RE: PETITION FOR SPECIAL EXCEPTION
N/New Sulphur Spring Road, 83'
W/centerline of Waelch Avenue
13th Election District
John A. Farley, Jr.,
Petitioner
Case No. 86-30-X

The Petitioner herein requests a special exception for a Class "B" office building in a R.O. zone.

SUBJECT: COUNTY REVIEW GROUP COMMENTS DATE: April 17, 1985
FROM: OFFICE OF PLANNING AND ZONING

PROJECT NAME: The Farley Property PLAN XXXXXXXXXXXXXXXXXXXX
COUNCIL & ELECTION DISTRICT XIII-100 PLAN EXTENSION
REVISED PLAN
PLAT

C.R.G. PLAN - EXHIBIT

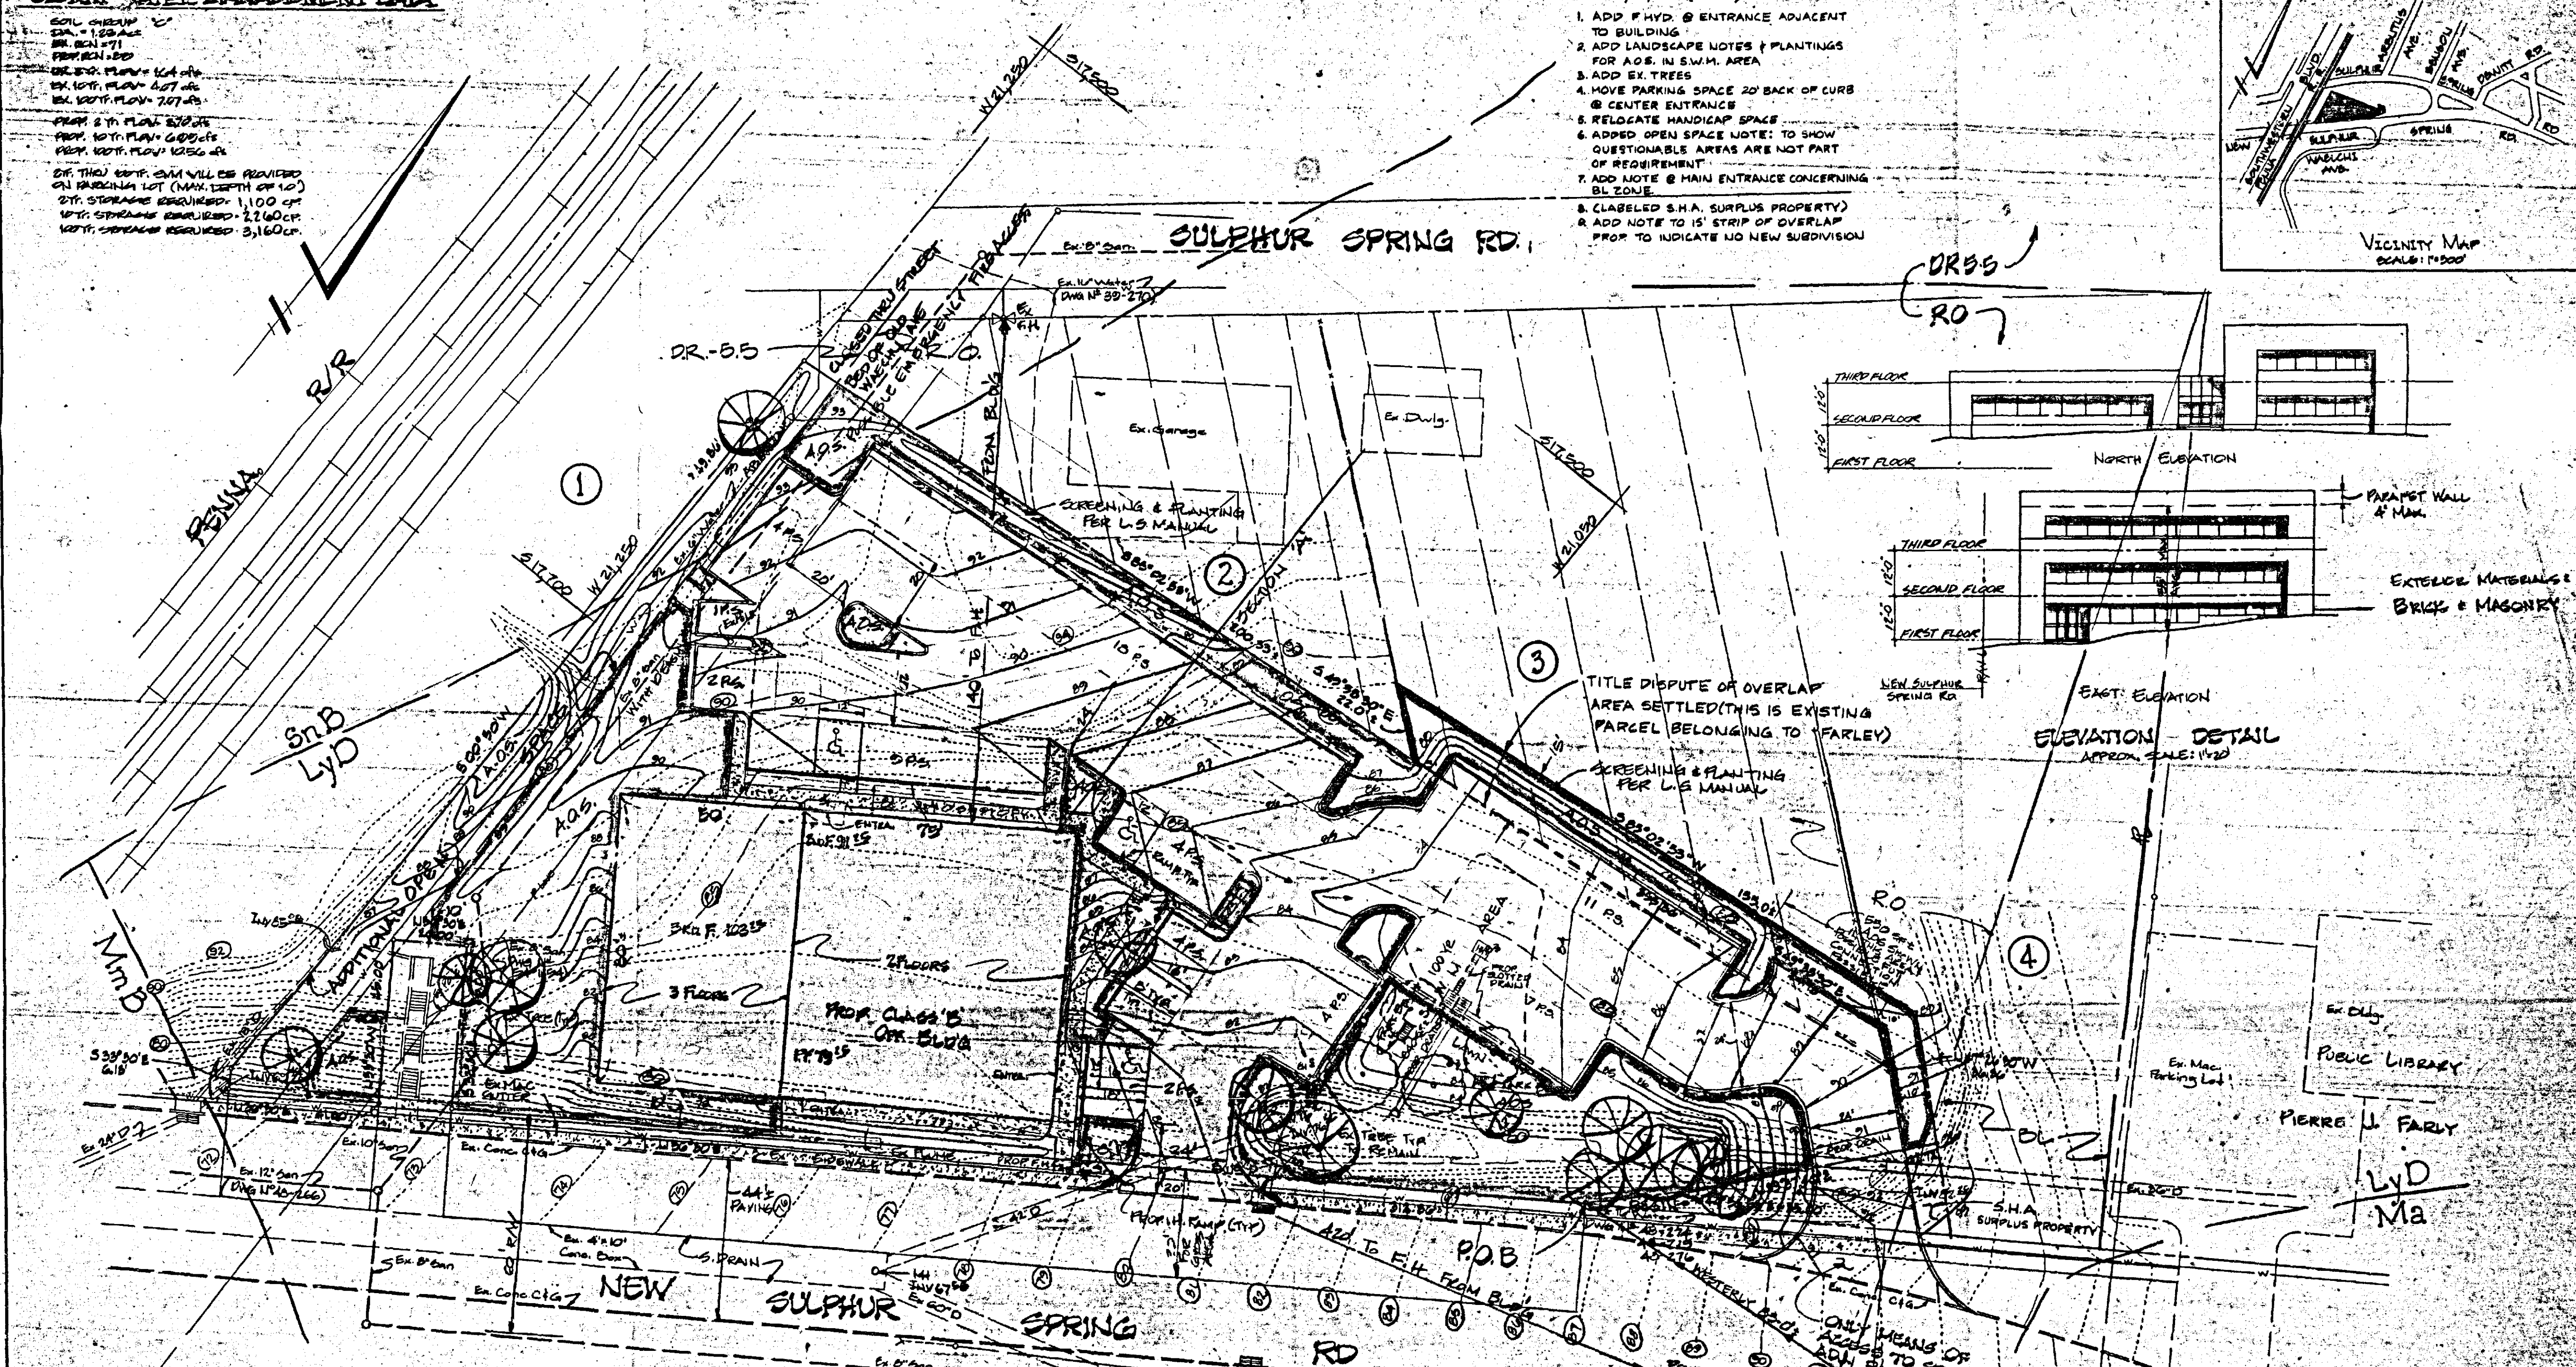
1. ADD FHYD. @ ENTRANCE ADJACENT TO BUILDING.
2. ADD LANDSCAPE NOTES & PLANTINGS FOR AOB. IN S.W.M. AREA
3. ADD EX. TREES
4. MOVE PARKING SPACE 20' BACK OF CURB @ CENTER ENTRANCE
5. RELOCATE HANDICAP SPACE
6. ADDED OPEN SPACE NOTE: TO SHOW QUESTIONABLE AREAS ARE NOT PART OF REQUIREMENT
7. ADD NOTE @ MAIN ENTRANCE CONCERNING BL ZONE.

1. (LABELED S.H.A. SURPLUS PROPERTY)
2. ADD NOTE TO 15' STRIP OF OVERLAP PROP. TO INDICATE NO NEW SUBDIVISION

C.R.G. PLAN EXHIBIT

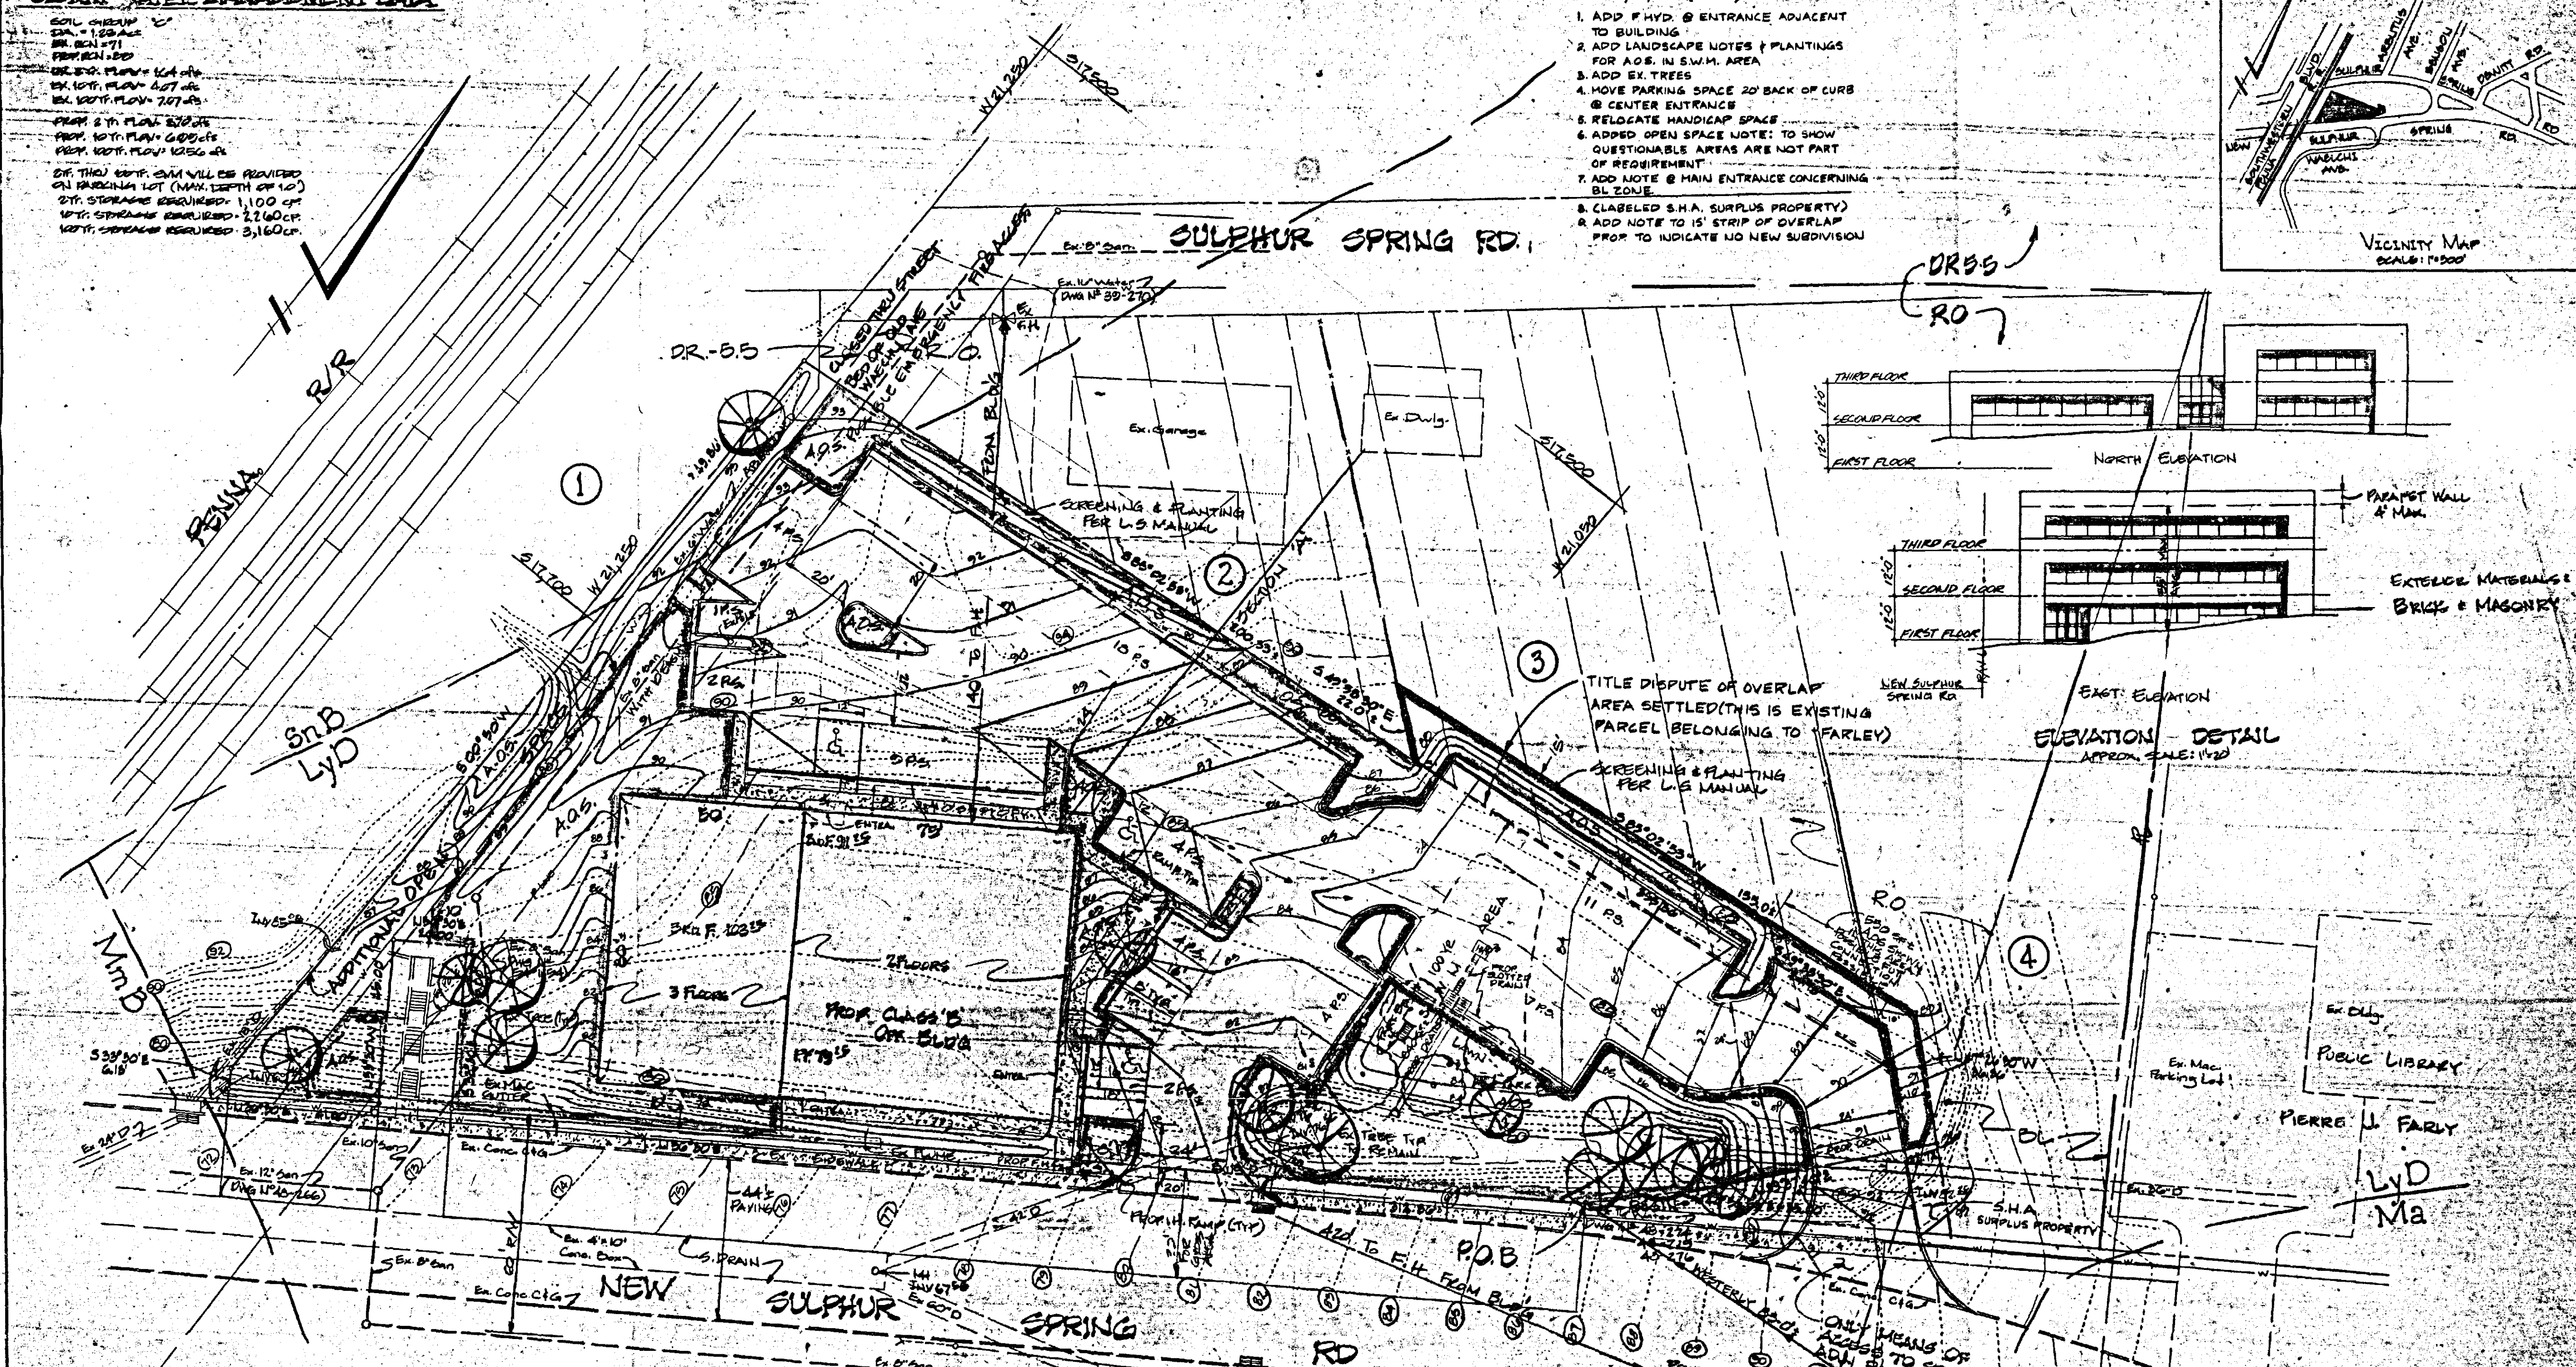
1. ADD FHYD. @ ENTRANCE ADJACENT TO BUILDING.
2. ADD LANDSCAPE NOTES & PLANTINGS FOR AOB. IN S.W.M. AREA
3. ADD EX. TREES
4. MOVE PARKING SPACE 20' BACK OF CURB @ CENTER ENTRANCE
5. RELOCATE HANDICAP SPACE
6. ADDED OPEN SPACE NOTE: TO SHOW QUESTIONABLE AREAS ARE NOT PART OF REQUIREMENT
7. ADD NOTE @ MAIN ENTRANCE CONCERNING BL ZONE.

1. (LABELED S.H.A. SURPLUS PROPERTY)
2. ADD NOTE TO 15' STRIP OF OVERLAP PROP. TO INDICATE NO NEW SUBDIVISION
